TMI_908-GW(2)-01

Issue Identifier	Age IR	Age	Age Group / Order	Reference to Information Request	
TMI_908-GW(2)-01	GW(2)-01	1	CEA Agency	Reference to EIS Guidelines:	Part 2, Sections 9.1.1 and 9.1.2
				Reference to EIS / Appendix	n/a
				Cross-reference to Round 1 IRs	TMI_72-GW(1)-09, TMI_74-GW(1)-11, TMI_75-GW(1)-12, TMI_83-GW(1)-20, TMI_115-SW(1)-29
				<p>Identified Risks</p> <p>The groundwater model has a number of deficiencies, listed below, which raise uncertainties with the modelling exercise, the outputs of the model, and the effects assessments that incorporate those model outputs. These concerns are also tied with concerns raised in other IRs related to characterization of geochemistry on the site (see CEAA 31, 24 to 26 and 33), cover options for TSF and WRSAs (see CEAA 9 to 11 and 30), and TSF base and liner (see CEAA 14 and 29).</p> <ol style="list-style-type: none"> 1) Recharge rate uncertainty Recharge was based on very limited field observations which were conducted during unusually dry years (Appendix M of the revised EIS, Section 3.2 and Figure 9). Recharge rates have important implications for modelling the quantity of seepage. 2) Recharge rate uncertainty (WRA)

SEEPAGE COLLECTION DITCH TYPE A-1
BEDROCK AT OR CLOSE TO SURFACE

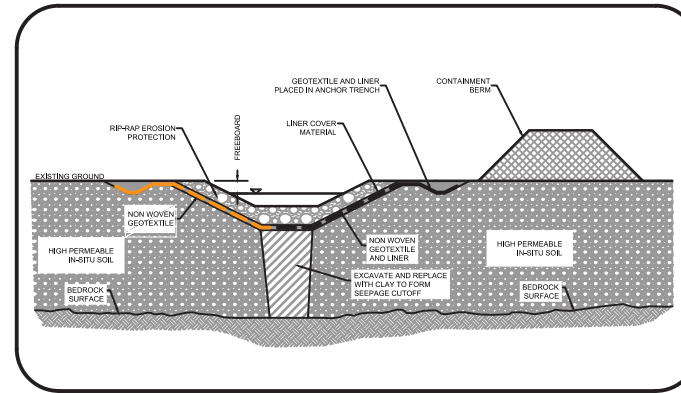
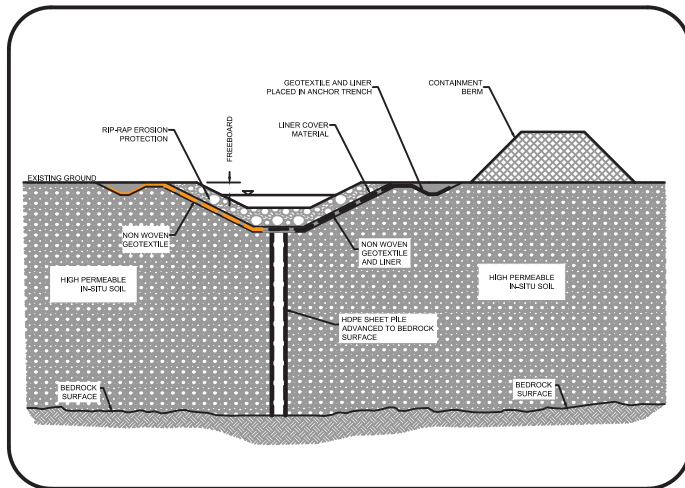
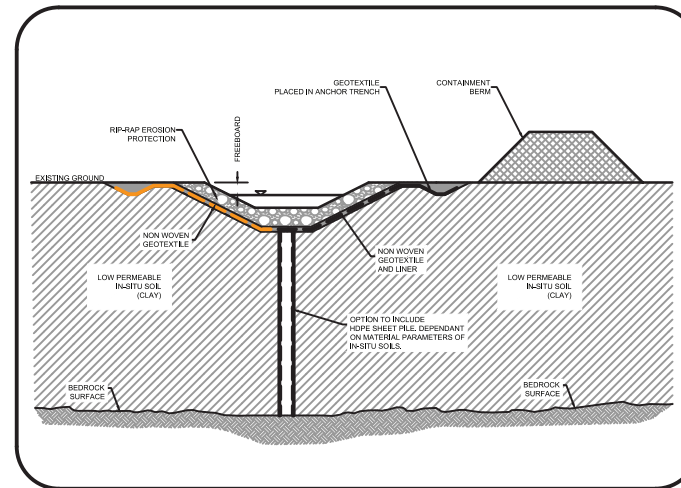
Issue Identifier	Age IR	Age	Age Groundwater	Request/Response
				<p>Proponent as it is stated that they are “conceptual, for discussion only”. Pumping wells have not been proposed as an option.</p> <p>Clarify whether the perimeter ditches and Mine Water Pond will still be in place during Post-closure, and if so, where will they direct the seepage (See Comment ID# 7 in Water Addendum)</p> <p>Part C.</p> <p>Recommend that this section be evaluated once inter-related comments from other IRs are addressed.</p> <hr/> <p><u>Seepage Response Age</u></p> <p><u>Part A</u></p> <p>As discussed in the December 18, 2018 meeting with the Agency and their technical reviewers, the kinematic porosity used to assess groundwater velocities was selected to represent the bulk material of the site as described fully in the response to TMI_951-GW(2)-01B. NRCAN noted at the meeting, kinematic porosity may be estimated in the field using tracer testing. However, this methodology is not suitable to estimate bulk kinematic porosity from the shallow bedrock and basal sand overburden. As part of the Follow-up Program for groundwater, monitoring data will be able to detect the arrival of seepage from the mine. Detection of relatively non-retardant species (chloride, sulphate), will be used to establish bulk kinematic porosity values for the geology at the site. Detection of retardant species (metals, cyanide) will be used to establish transport parameter values (retardation, decay where applicable).</p> <p><u>Part B</u></p> <p>Perimeter Ditches</p> <p>The groundwater modelling completed for the Goliath Gold Project was run using the default ditch configurations of 1 m in depth (Figure 3.7.3-1 of the revised EIS). The results of the modelling indicated that these ditches would be effective at capturing 34% of the small amount of seepage from the TSF. The groundwater model was not run specifically for the additional ditch configurations illustrated on TMI_910-GW(2)-04_Attachment_1 as it is not possible to know which of the configurations would specifically be used at every location around the operation area. The alternative configurations shown on TMI_910 GW(2) 04_Attachment_1 represent a “toolbox of options” that will be used to select the configuration of ditches constructed around the perimeter of the site, based on the actual conditions encountered when constructing the perimeter ditches. The four configurations in TMI_910-GW(2) 04_Attachment_1 are labelled as “conceptual” and “for discussion only” as the detailed engineering for these features has yet to be completed. The final design for the construction of the perimeter ditches will be done to address specific conditions that are encountered. Another option that could be considered in the “toolbox” for the Project are pumping wells; however, these are unlikely to be the first options selected based on the site conditions and projected seepage.</p> <p>Although the seepage collection efficiencies for the alternative ditch configurations illustrated on TMI_910-GW(2)-04_Attachment_1 were not specifically modelled, the performance of these alternative configurations is expected to be considerably higher than 34%, ideally capturing 100% of the seepage from the site. To ensure the</p>

Issue Identifier	Age IR	Area	Age Groundwater Order	Response
				<p>aquifers, but posits a value of 1% is possible. The kinematic porosity of 0.01 used for the groundwater velocity calculation (memo to Mark Wheeler, Treasury Metals; “Additional Hydrogeological Information”, dated March 29, 2018, as appended to Appendix M) represents the porosity of open, weathered fractures at the bedrock surface. The Basal Sand at the base of the overburden is discontinuous as noted in the memo referred to above. Nevertheless, as fractures in the shallow bedrock will also be discontinuous, it is correct that flowpaths may exist that go through both shallow bedrock and the Basal Sand. However, groundwater velocities in the Basal Sand are more likely lower than in the shallow bedrock as the kinematic porosity of the Basal Sand is expected to be about an order of magnitude higher, whereas the hydraulic conductivities are expected to be of a similar range (see Table 8 of Appendix M).</p> <p>Nevertheless, Treasury Metals do recognize that there is uncertainty in the estimate of groundwater velocity, and acknowledges that groundwater velocities may be of the order of 2×10^{-6} m/s. As discussed in the December 18, 2018 meeting with the Agency and their technical reviewers, the kinematic porosity used to assess groundwater velocities was selected to represent the bulk material of the site as described fully in the response to TMI_951-GW(2)-01B. NRCan noted at the meeting, kinematic porosity may be estimated in the field using tracer testing. However, this methodology is not suitable to estimate bulk kinematic porosity from the shallow bedrock and basal sand overburden. As part of the Follow-up Program for groundwater, monitoring data will be able to detect the arrival of seepage from the mine. Detection of relatively non-retardant species (chloride, sulphate), will be used to establish bulk kinematic porosity values for the geology at the site. Detection of retardant species (metals, cyanide) will be used to establish transport parameter values (retardation, decay where applicable).</p> <p><u>Part B.</u></p> <p>Perimeter Ditches</p> <p>Since the filing of the original EIS, Treasury Metals has advanced their engineering for the Project, which includes additional details regarding the design of seepage and runoff collection ditches, as described in Section 3.7.3 of the revised EIS. While Figure 3.7.3-1 of the revised EIS (April 2018) provides typical cross sections for seepage and runoff collection ditches, Figure 3.7.3-2 (attached as TMI_910-GW(2)-03_Attachment 1) provides modifications specifically to address situations where existing conditions may pose challenges to the collection and capture of seepage including deep bedrock in both low and high permeability soils.</p> <p>The groundwater modelling completed for the Goliath Gold Project was run using the default ditch configurations of 1 m in depth (Figure 3.7.3-1 of the revised EIS). The results of the modelling indicated that these ditches would be effective at capturing 34% of the small amount of seepage from the TSF. The groundwater model was not run specifically for the additional ditch configurations illustrated on TMI_910-GW(2)-04_Attachment_1 as it is not possible to know which of the configurations would specifically be used at every location around the operation area as these alternative configurations shown on TMI_910 GW(2) 04_Attachment_1 represent a “toolbox of options” that will be used to select the configuration of ditches constructed around the perimeter of the site, based on the actual conditions encountered when constructing the perimeter ditches. The four configurations in TMI_910-GW(2) 04_Attachment_1 are labelled as “conceptual” and “for discussion only” as the detailed engineering for these features has yet to be</p>

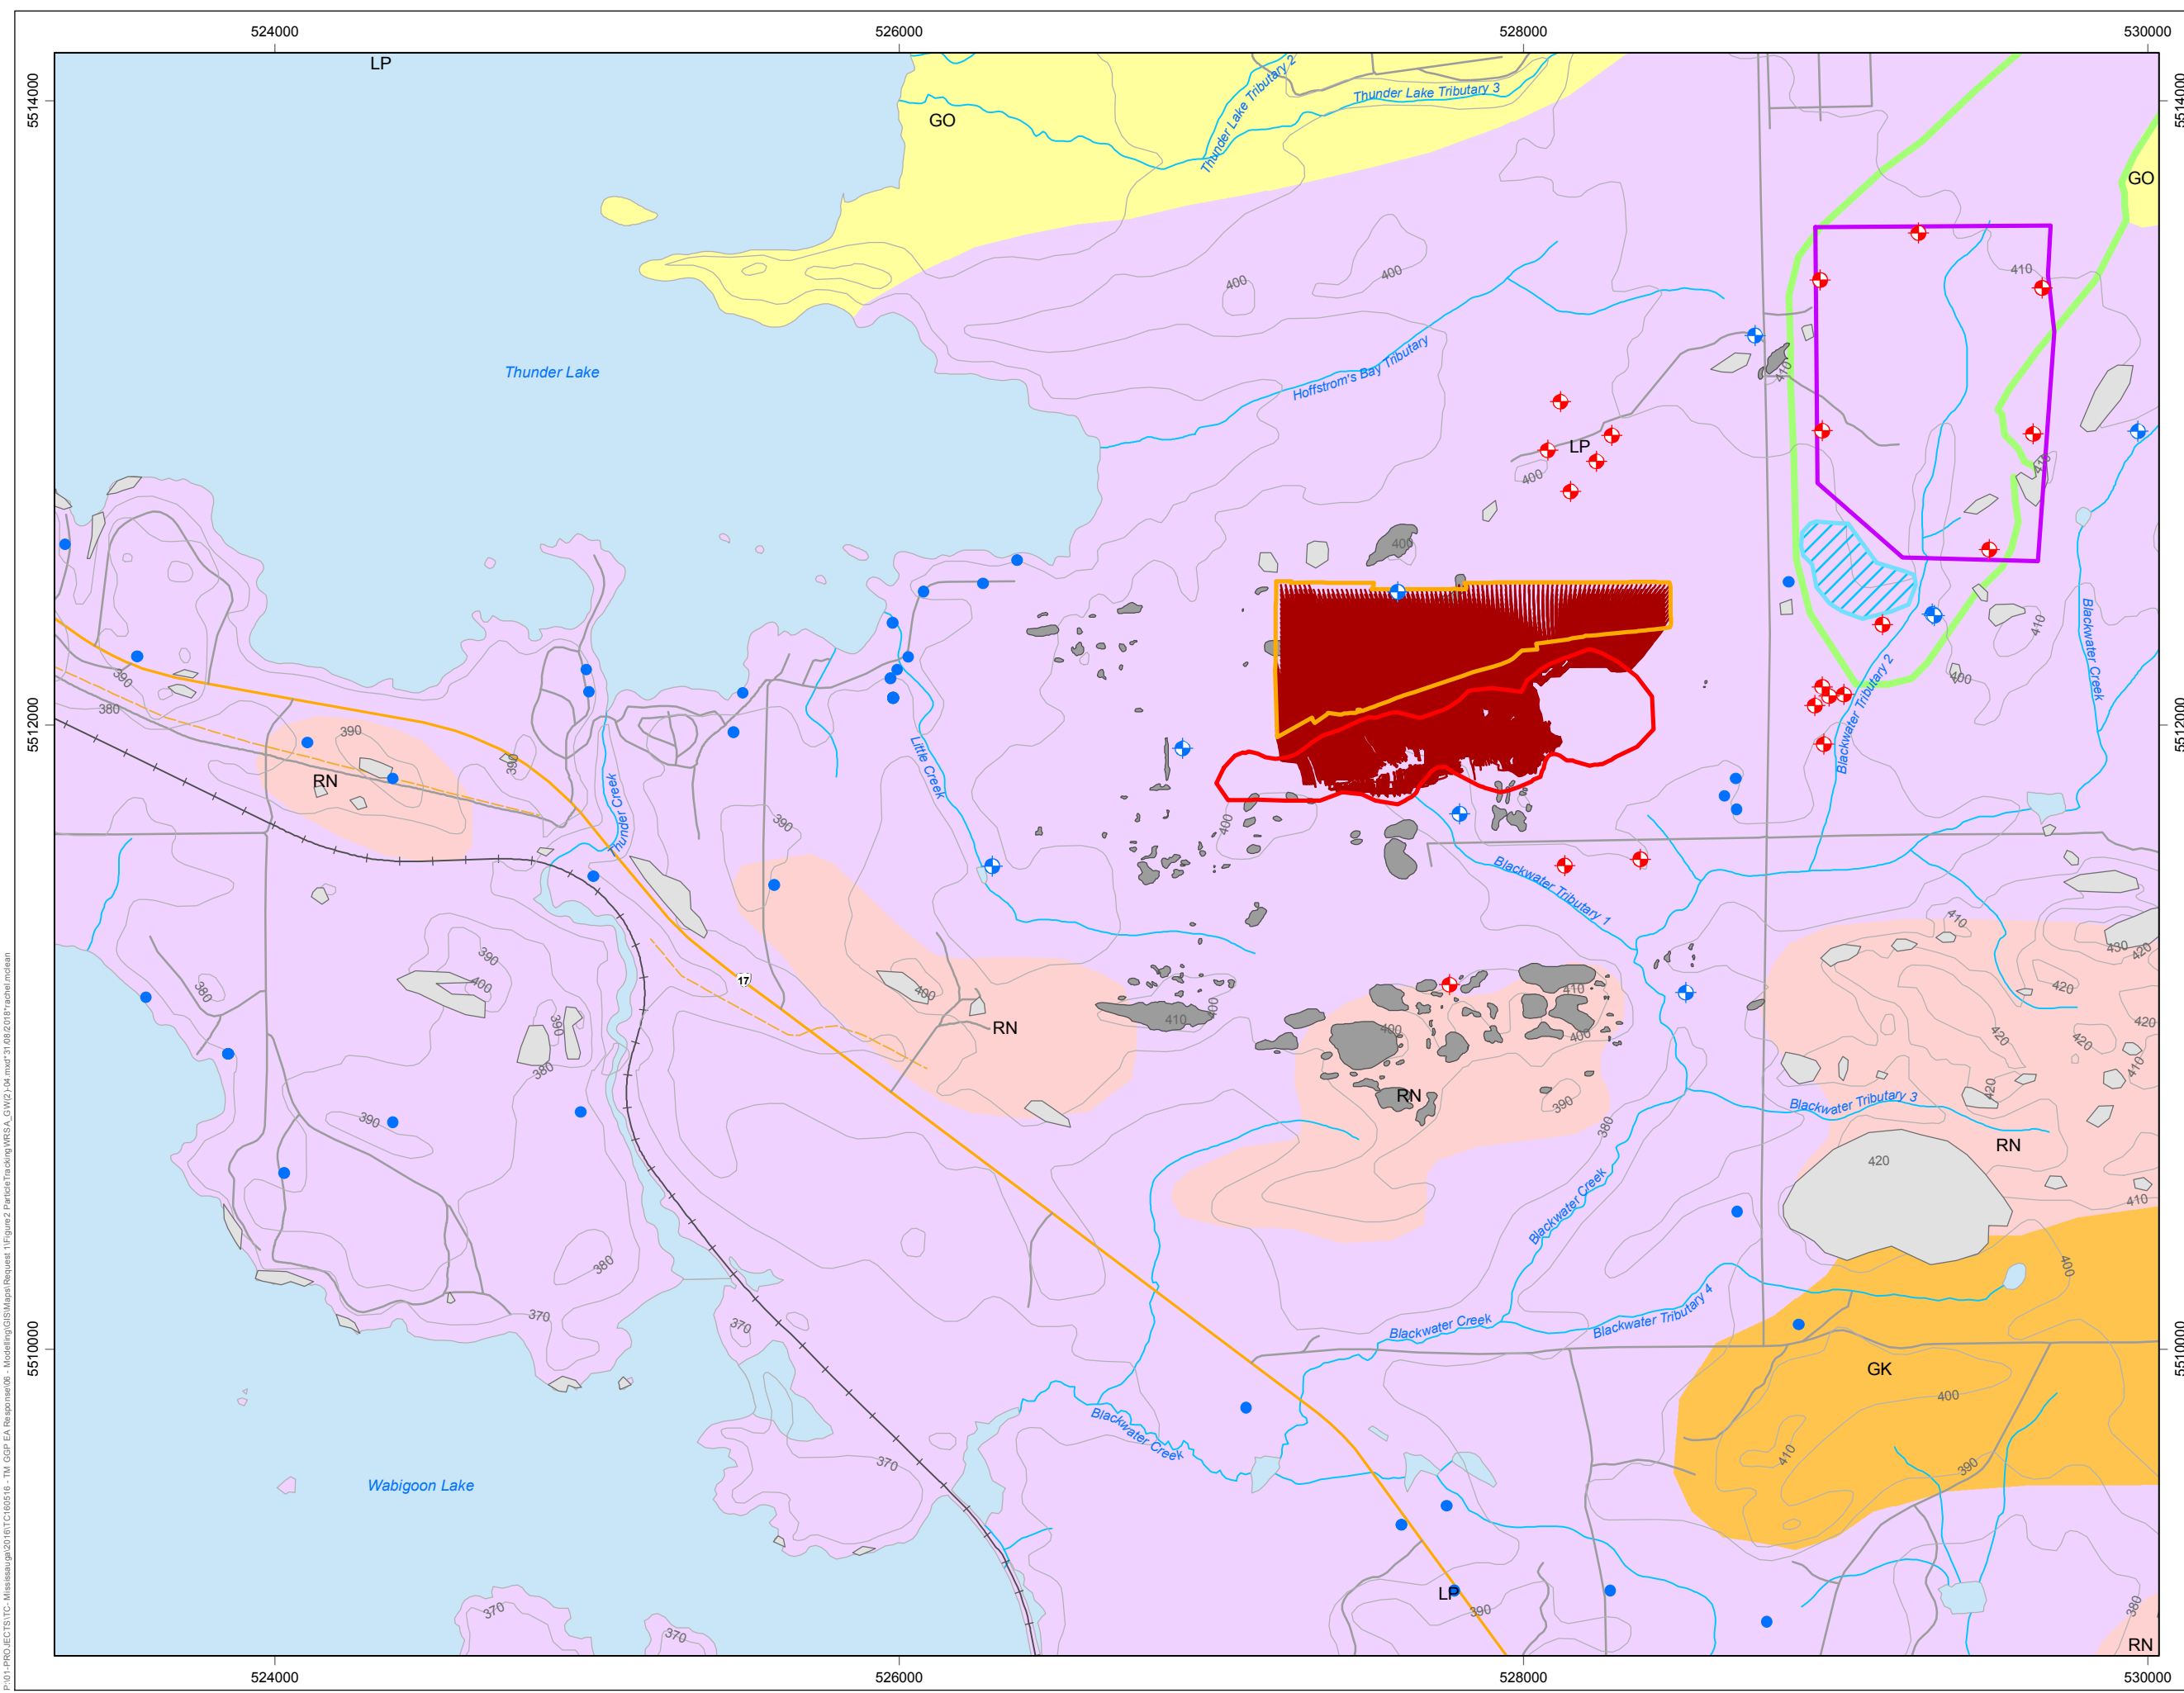
<p>Issue Identifier Reference to EIS Guidelines</p> <p>A. Provide a particle tracking figure for the dewatered pit scenario, and reconsider the conclusion that all of the seepage bypass during the operation phase would be captured by the open pit drawdown force.</p> <p>B. Incorporate the findings of this IR into the revision of seepage water quality assessment requested in IR# MW(2)-06, and revision of groundwater model requested in IR# GW(2)-01.</p>

Issue Identifier	Age IR	Area	Age Group Order	Request Reference Identifier Request
				<p>Request</p> <p><u>Part A:</u></p> <p>Specially conducted model runs have been undertaken with the Goliath groundwater flow model assuming the ultimate open pit and underground mine are completely dewatered and with an uncapped WRSA and an unlined and uncapped TSF. The simulated conditions of the WRSA and TSF are the same as the simulations for uncapped conditions described in Section 5.3.5 of Appendix M of the revised EIS (April 2018). Particle tracking results for the TSF and WRSA are shown in TMI_911-GW(2)-04_Figure_1 and TMI_911-GW(2)-04_Figure 2, respectively. The results are discussed further below.</p> <p>Releases from TSF</p> <p>The simulation has been undertaken to provide a physically realistic particle tracking release from the full footprint of the TSF. The water cover of the TSF is maintained 418 masl, which provides the driving head for flow out of the TSF. The results show that, of the seepage leaving the TSF, 46% is captured by the open pit; 34% is captured by the TSF perimeter drains; 14% is captured by the mine water pond, and 6% escapes the operations area and reports to Blackwater Creek. The proportion that escapes the operations area to report to Blackwater Creek occurs along the eastern perimeter of the TSF.</p> <p>As discussed in the responses to TMI_900-MW(2)-04 and TMI_901-MW(2)-05; the TSF will be lined with an HPDE liner. The estimated seepage rate for the TSF liner of 2.4 m³/day represents the approximate upper bound estimate for a properly installed HDPE geomembrane underlying mine tailings (Kerry Rowe et al., 2016). The estimated seepage rate is independent of the soil characteristics underneath the TSF liner.</p> <p>Based on the upper bound estimate of seepage through the TSF liner (2.4 m³/day), the leakage from the TSF towards Blackwater Creek would be small (2.4 m³/day × 0.06 = 0.14 m³/day). This small amount of seepage during operations has been incorporated into the revised surface water quality assessment provided in the Water Addendum.</p> <p>Releases from WRSA</p> <p>Particle tracking results shown in TMI_911-GW(2)-04_Figure 2 indicate that all water seeping from the base of the uncapped WRSA during operations is captured by the open pit. This is consistent with the assumption relied on in the revised EIS (April 2018).</p> <p><u>Part B:</u></p> <p>The surface water quality assessment has been updated as part of the Round 2 process, to reflect all necessary changes, refinements, or concerns identified in the Round 2 process. As described in the response to Parts A, a small amount of seepage (i.e. 6% of 2.4 m³/day) from the TSF will report to Blackwater Creek during operations. The particle tracking confirms that all of the seepage from the uncapped WRSA reports to the open pit during operations. The information presented in this Round 2 response, has been incorporated into Section W6.5 of the Goliath Gold</p>

Issue Identifier	Age IR	Area	Age Groundwater Identifier	Information Request Response
				<p>Particle Tracking for the Operations Phase</p> <p>As discussed in the December 18, 2018 technical meeting with the Agency and their technical reviewers, the cross sections provided as Figures 5a and 5b of Appendix M of the revised EIS (April 2018) show that the clay layer present under much of the site is absent beneath the tailings storage facility (TSF). Figure 4 of Appendix M to the revised EIS (April 2018) provides the location of cross-section A (Figure 5a) and cross-section B (Figure 5b). The groundwater model predicts a vertical downward gradient beneath the TSF. Lateral movement of seepage from the TSF is predicted to occur in the basal sands and shallow weathered bedrock that exists beneath the overburden layers.</p> <p>TMI_911 GW(2) 04_Figure_1 provides the operations phase particle tracking for the fate of seepage from the TSF. The particle tracks from the TSF towards the open pit (purple tracks in the figure) represent flow primarily through the discontinuous basal sands and shallow weathered bedrock that occurs below the overburden layer. The surficial geology suggests that Hoffstrom's Bay Tributary (see Figure 5b) and Blackwater Tributary #2 to the south to the south of the TSF (see Figure 5a) are underlain with clay, and thus would be isolated from the seepage from the TSF that is travelling laterally through the basal sands and shallow weathered bedrock that exists beneath the overburden layers.</p> <p>Particle Tracking for the Post-Closure Phase</p> <p>Particle tracking figure for the post-closure phase were provided in Appendix M to the revised EIS (April 2018). The following particle track figures are provided in Appendix M:</p> <ul style="list-style-type: none"> • Figure 22: particle tracking results for the seepage from the TSF with a wet cover (i.e., uncapped); • Figure 24: particle tracking results for the seepage from the TSF with a dry cover (i.e., capped); and • Figure 25: particle tracking results for the seepage from the capped WRSA. <p><u>Part B.</u></p> <p>As discussed in the December 18, 2018 technical meeting with the Agency and their technical reviewers, the groundwater model predicts that a vertical downward gradient will exist during operations beneath the TSF. The lateral movement of seepage from the TSF will be through the basal sands and shallow weathered bedrock that exists beneath the overburden layers. The mechanism to support this is illustrated in the cross sections provided as Figures 5a and 5b of Appendix M of the revised EIS (April 2018), which show that the clay layer present under much of the site is absent beneath the tailings storage facility (TSF). Therefore, no additional changes to capture the effects of seepage incorporated into the surface water quality model described in the Goliath Gold Project Water Addendum. The Water Addendum presents the updated water quality assessment that consolidates all of the identified Round 2 changes and concerns including those changes to groundwater and mine waste that would affect surface water quality.</p>
